CHAPTER 9.0 LETTERS OF COMMENT AND RESPONSES

This section of the Final EIR (FEIR) presents copies of comments on the DEIR received in written form during the public review period, and it provides the County of San Diego's responses to those comments. Each comment letter is lettered and the issues within each comment letter are bracketed and numbered. Comment letters are followed by responses, which are numbered to correspond with the bracketed comment letters.

Graph 1 - Common Spectral Surfaces

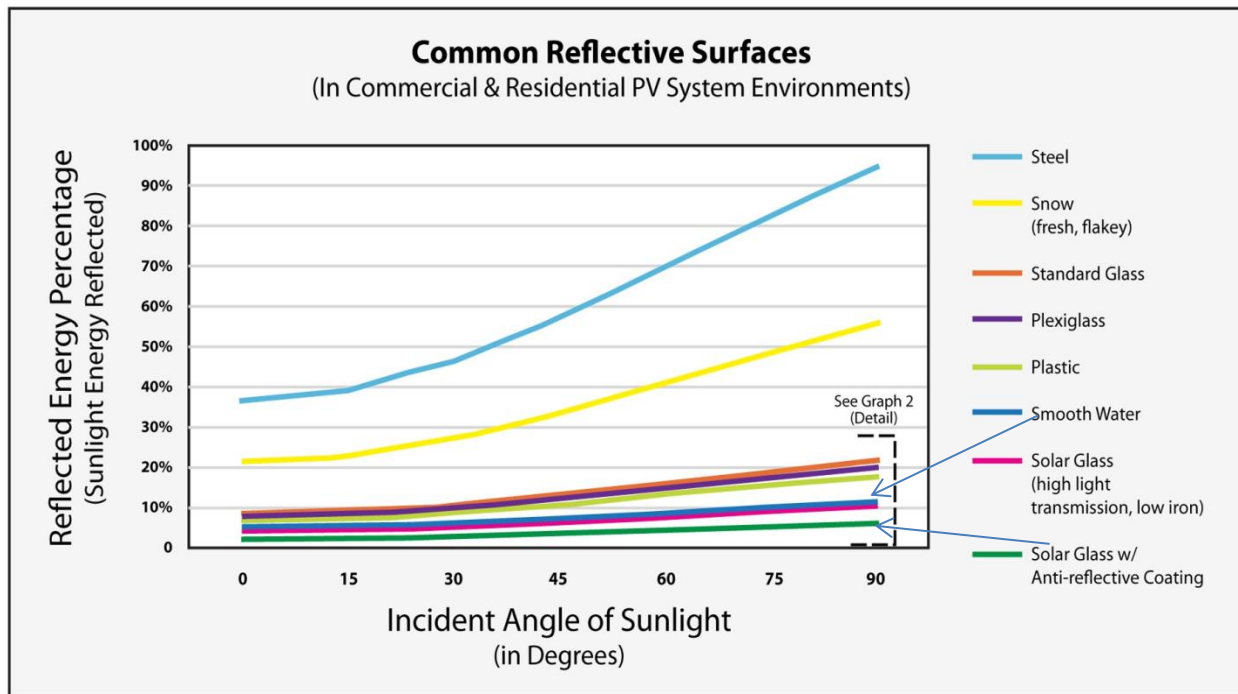
BIO1- Pseudo-Lake Effect. As described in DEIR page 2.2-34, the Proposed Project area is located within the Pacific Flyway for migratory avian species; however, the Proposed Project site is located east of the main coastal migration route and west of the primary route between the Gulf of California and the Salton Sea. The potential effects of the pseudo-lake effect are discussed on pages 2.2-46 and 2.2-47 of the DEIR. The analysis acknowledges anecdotal evidence of wetland species colliding with or becoming stranded in solar fields, that some have hypothesized is possibly because birds might be attracted to the solar arrays if the solar arrays mimic water bodies. Little is known about whether avian species and individuals that are negatively affected by glare or the hypothesized pseudo-lake effect of PV arrays. The USFWS recognizes the lack of data on the effects of solar facilities on migratory bird mortality and has provided guidance on monitoring migratory bird mortalities at solar facilities (Nicolai et al. 2011). The April 2015 National Renewable Energy Laboratory (NREL) report on Avian Monitoring and Mitigation at solar facilities states, “[l]astly, it has also been hypothesized that utility-scale PV facilities may attract migrating waterfowl and shorebirds through what has been called the “lake effect” (Kagen et al. 2014), whereby migrating birds perceive the reflective surfaces of PV panels as bodies of water and collide with project structures as they attempt to land on the panels. To date, however, no empirical research has been conducted to evaluate the attraction of PV facilities to migrating birds.” (NREL 2014 at p. 11.).

Accordingly, the experts that prepared the DEIR reviewed the available literature and found no credible evidence that the Project creates a significant pseudo lake effect threat to avians and therefore CEQA does not require alterations to the Project’s location or design to mitigate an impact that is not significant or too speculative for evaluation. CEQA Guidelines 15126.4(a)(3) states, “[m]itigation measures are not required for effects which are not found to be significant.” The CEQA Guidelines further specify that “if, after thorough investigation, a lead agency finds that a particular impact is too speculative for evaluation, the agency should note its conclusion and terminate discussion of the impact.” (CEQA Guidelines, §15145.) When determining whether an EIR complies with applicable legal requirements, courts may not interpret CEQA or the CEQA Guidelines in a manner that would impose procedural or substantive requirements

Furthermore, the Proposed Project is backed up between a mountain and a large existing fence (International Border Fence). The Proposed Project would have solar units that are uniformly dark in color, coated to be non-reflective, and designed to be highly absorptive of all light that strikes their glass surfaces so they would not appear like water from above, as water displays different properties by both reflecting and absorbing light waves. (See DEIR, p. 2.2-47.) The Proposed Project's panels are approximately 12.5 feet apart, which breaks up sky reflection from a single continuous surface to individual separate units and reduces the image of a continuous body of water. The charts included below demonstrate the low reflectivity of PV panels with anti-reflective coatings like the ones for this Project compared to other surfaces, including water (Common Reflective Surfaces Source: SUNPOWER 2010, PV Systems: Low Levels of Glare and Reflectance vs. Surrounding Environment).
